LAND COURT OF QUEENSLAND

**JOINT EXPERT REPORT - GROUNDWATER CONCEPTUALISATION, GROUNDWATER
QUALITY AND GROUNDWATER MODELLING**

New Acland Coal Mine Stage 3 (G1680A)

**Walloon Coal Measures aquifer
Predicted drawdown with and without
faults - end of mining (2030)**

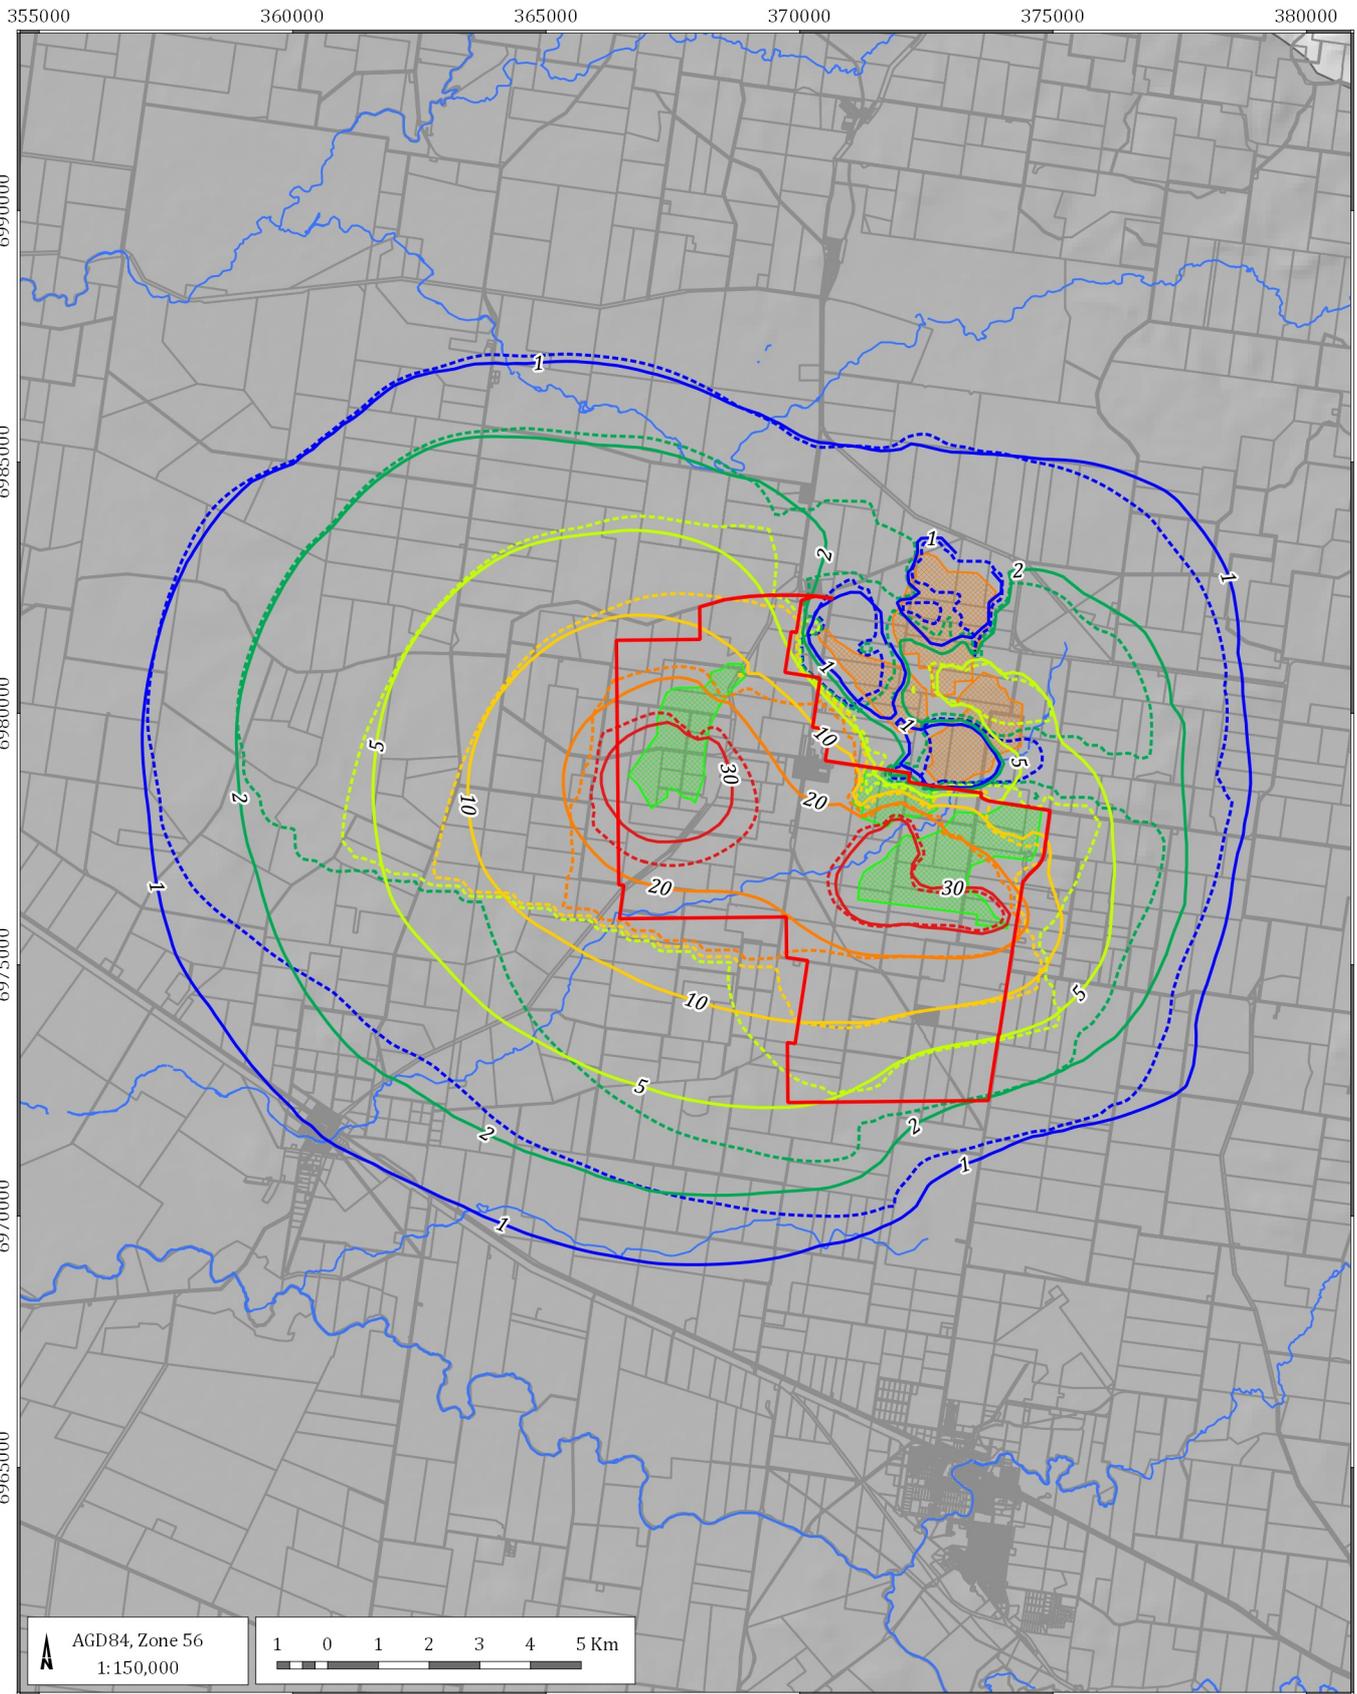
2.8 **1(e)(ii)B. The assumption that this fault acts as a barrier to groundwater flow has major implications for the predicted extent of the Project's impacts.**

- (a) MC and DI agree on this point. AD had in fact re-run the groundwater model reported in the AEIS³ without the horizontal flow barrier package (representing the faults), and the results showed increased drawdown extents in those places where faults were removed from the model. The difference in drawdown extents is shown in Figure 1.
- (b) If on the other hand, for example, the fault mapped by New Hope Group (and provided by AGE in Figure 2), with 50m throw to the southwest of the Project, acts as a barrier to flow, then drawdown from the mine could extend further to the southeast of the mine lease, towards Oakey Creek. MC and DI agree that there remains uncertainty with respect to the role of faults in the propagation of drawdown from the Project.

Figure 2 Geological cross section A-A' generated from NHG geology model

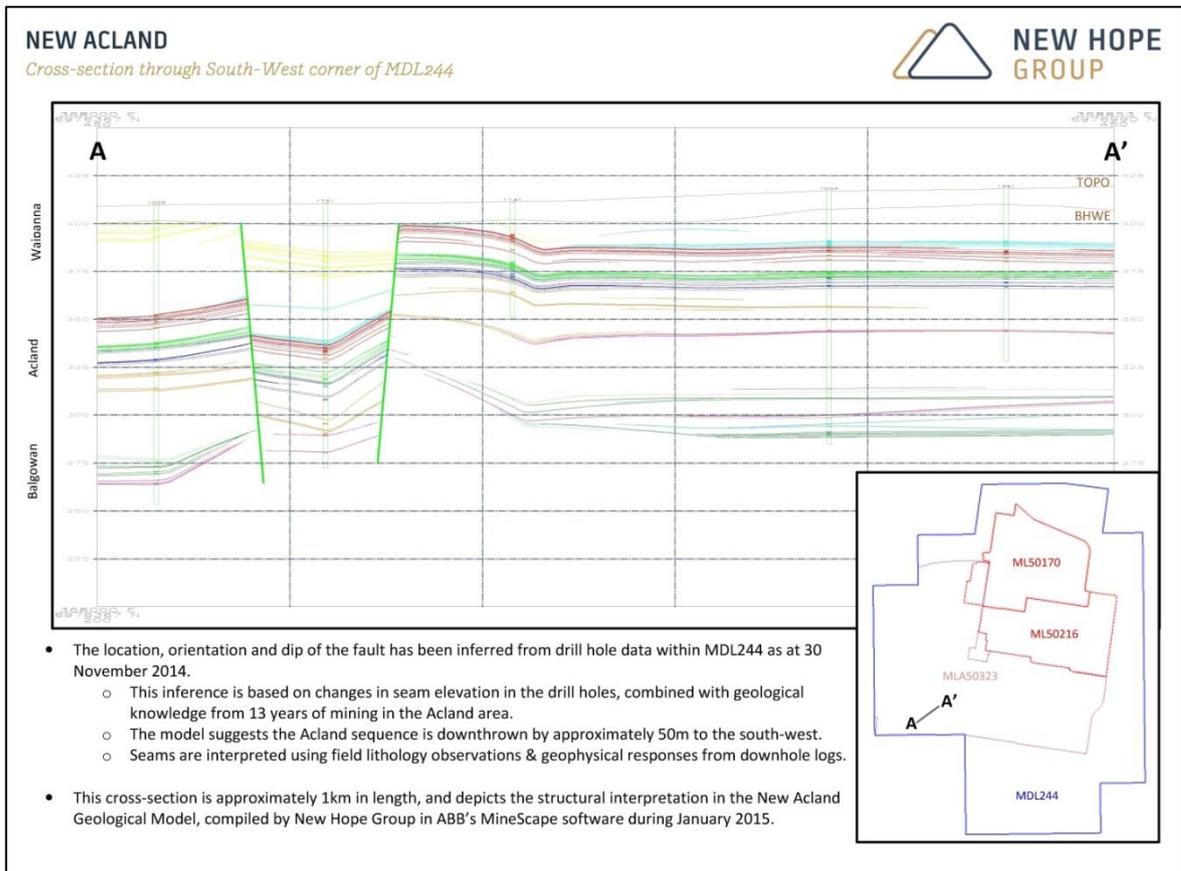
2.7 **1(e)(ii)A. A major fault immediately to the south of the Project area is conceptualised as being a barrier to groundwater flow, however, little field evidence is provided to justify this conceptualisation.**

- (a) MC and DI agree on this point, and agree that there was insufficient justification of the faulting in reporting the conceptual hydrogeological model.
